Simplification of lighting and light-signalling UN Regulations: UN Regulation No. 150 (Retro-Reflective Devices)

Revised proposal to correct and improve the text of UN Regulation No. 150

Submitted by the Informal Working Group on Simplification of Lighting and Light-Signalling Regulations*

Figure A24-II

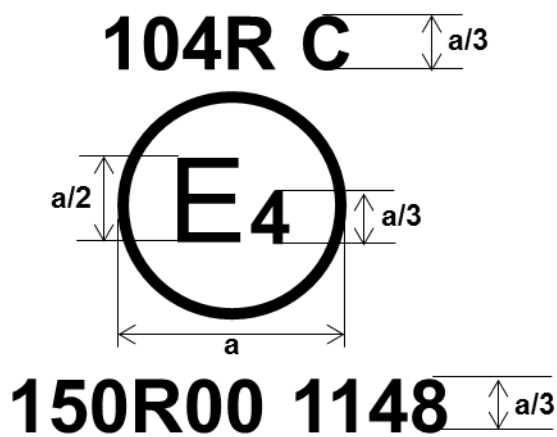
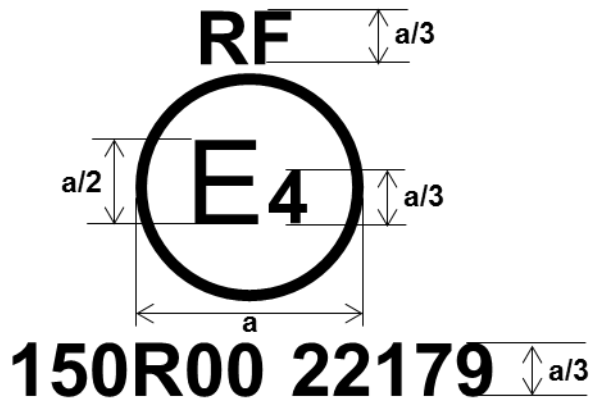
Annex 24, amend to read:

6. Annex 24 has been editorially reorganized and streamlined without changing its contents. The figures have been corrected to provide examples of the approval marks using

the new UN Regulations. For the size of “a”, the reference was corrected in order to refer to Table 1 instead of Table 2.
